REGION OF OTTAWA CARLETON

SUBJECT/OBJET **REFERENCE ITEM 5
PLANNING AND ENVIRONMENT COMMITTEE AGENDA
24 OCTOBER 2000**

Attached please find copies of Annexes A, B, C and D to be considered in conjunction with Item 5 of the Planning and Environment Committee Agenda, "1394843 Ontario Inc. - 1241 Clyde Avenue - Former Department of Communications (DOC) Lands Subdivision, City of Ottawa". Annex A is the Regional Conditions for Final Approval for this subdivision. The version of this Annex attached to the PEC Agenda, contained incorrect numbering. Annexes B, C and D were inadvertently omitted from inclusion in the Agenda.

REGIONAL CONDITIONS FOR FINAL APPROVAL
134843 ONTARIO INC.
FORMER DOC LANDS SUBDIVISION - 1241 CLYDE AVENUE

Page 13 of
 LKS Letter
 of August 23-24
 2000

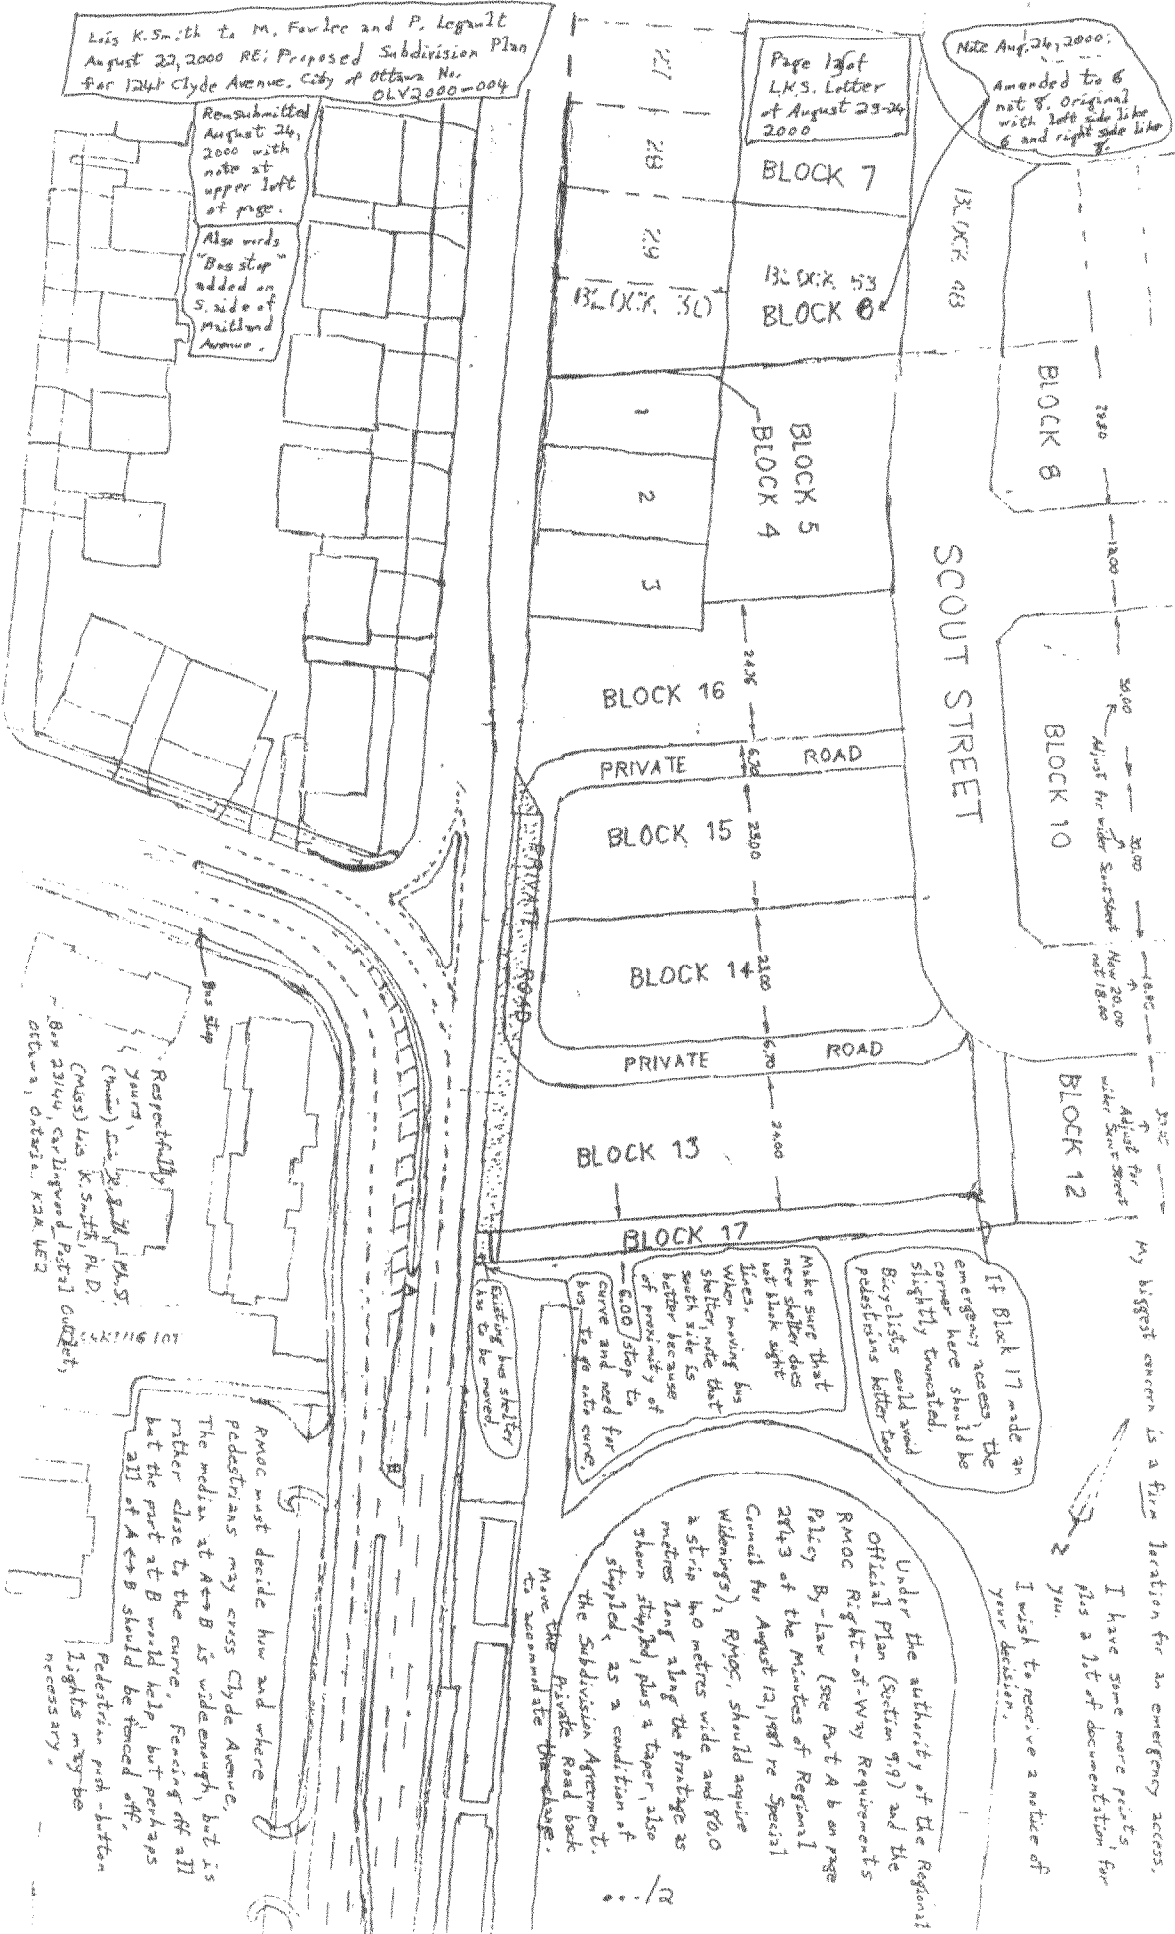
NRZ Aug 24, 2000;
 Amended to 6
 not 5. Original
 with left side like
 6 and right side like
 5.

Resubmitted
 August 24,
 2000 with
 note at
 upper left
 of page.
 Also words
 "Bus stop"
 added on
 S. side of
 Millwood
 Avenue.

Existing bus shelter
 has to be moved

Make sure that
 new shelter does
 not block sight
 lines.
 When moving bus
 shelter note that
 south side is
 better because
 of proximity of
 GO stop to
 curve and need for
 bus to go into curve.

If Block 17 made an
 emergency access the
 corner here should be
 slightly truncated.
 Bicyclists could avoid
 pedestrians better too.

My biggest concern is a firm location for an emergency access.
 I have some more points, plus a lot of documentation for you.
 I wish to receive a notice of your decision.

Under the authority of the Regional Official Plan (Section 9.9) and the RMAC Right-of-Way Requirements Policy By-Law (see Part A & on page 28/23 of the Minutes of Regional Council for August 12, 1987 re Special Widening), RMAC should acquire a strip 40 meters wide and 80.0 meters long along the fringe as shown stippled, plus a taper, also stippled, as a condition of the Subdivision Agreement. Move the Private Road back to accommodate this change.

RMAC must decide how and where pedestrians may cross Clyde Avenue. The median at A-B is wide enough, but is rather close to the curve. Fencing off all but the part at B would help, but perhaps all of A-B should be fenced off. Pedestrian path - better lights may be necessary.
